Connolly Center (Armory)

City of Everett ADA Transition Plan

July 2018

Institute for Human Centered Design

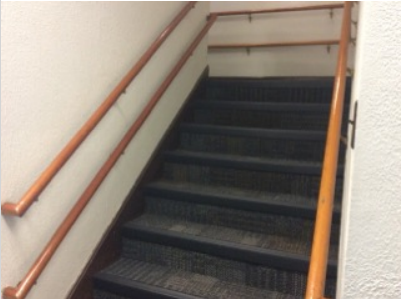
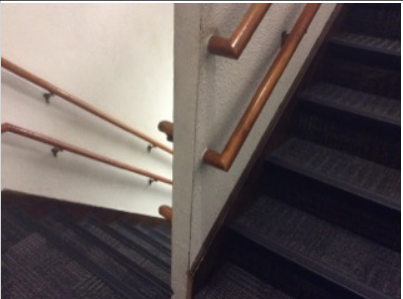
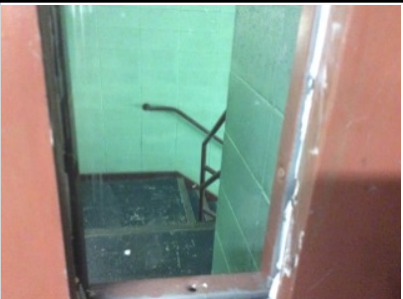
ID	Location	Element	Type	Photo	Issues	Current Measure	Recommendations	Quantity	Price	Cost Estimation
Pedestrian Access Routes										
Walking Surface										
1	Chelsea St.	Walking Surface	Sidewalk		Level changes > 1/4"	2"	Provide a tree grate.	1	1454	\$1454
Curb Ramps and Blended Transitions										
Perpendicular Curb Ramp										
2	Chelsea Place	Perpendicular Curb Ramp	N/A		Transition from curb ramp to street is not flush Surface not stable, firm and slip-resistant Detectable warning not provided	1" - -	Ensure transition from curb ramp to street is flush or free of changes in level. Repair surface. Provide a detectable warning on the curb ramp.	1	548	\$548
3	Armory Entrance	Perpendicular Curb Ramp	N/A		Surface not stable, firm and slip-resistant Detectable warning not provided	- -	Repair surface. Provide a detectable warning on the curb ramp.	2	283	\$566
Off-Street Parking Lot or Garage

Parking Lots										
4	Back Lot	Parking Lots	Vistor		Total # of parking Total # of designated accessible parking spaces Total # of designated van accessible spaces Access aisle not provided Sign does not have the designation "Van Accessible" Sign < 60" above finished grade	6 4 0 - - 48"	Provide at least 1 van accessible space. Provide a marked access aisle that is at least 96" wide. Provide a van accessible sign and locate sign with the bottom of the sign 60" above the ground.	1	400 Labor	\$400

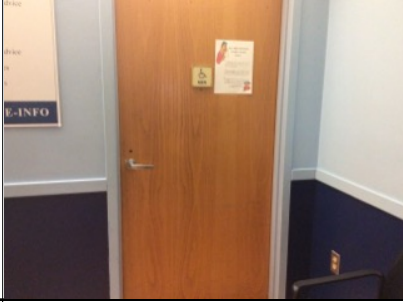
B. Interior Access Route												
10	Veterans Services Office	1		Interior Access Route	N/A		Route < 36" wide Obstructed by protruding objects	30" 6"	Ensure that a clear width of 36" min. is maintained at the accessible route. Replace the file folder with one that does not protrude into the circulation path.	1	Labor 128	\$128
11	Kitchen in Main Hall	1		Interior Access Route	N/A		Obstructed by protruding objects	22" -	Provide a cane detectable barrier at the drinking fountain.	1	439	\$439

C. Doors, Doorways, & Gates												
12	Main Hall to Main Entrance	1		Doors, Doorways, & Gates	Circulation		Threshold not beveled Threshold > 1/2" high	- 1"	Bevel threshold. Alter threshold to be 1/2" high max.	1	75	\$75
13	Women's Multi-User Toilet Room in Main Hall	1		Doors, Doorways, & Gates	Toilet Room		Threshold > 1/2" high Door requires > 5 lbs. of force to open	2" 15 lbs	Alter threshold to be 1/2" high max. Adjust closers so doors do not require more than 5 pounds of force to open.	1	75 Labor	\$75
14	Veterans Services Office	1		Doors, Doorways, & Gates	Circulation		Door requires > 5 lbs. of force to open	10 lbs	Adjust closers so doors do not require more than 5 pounds of force to open.	1	Labor	\$0
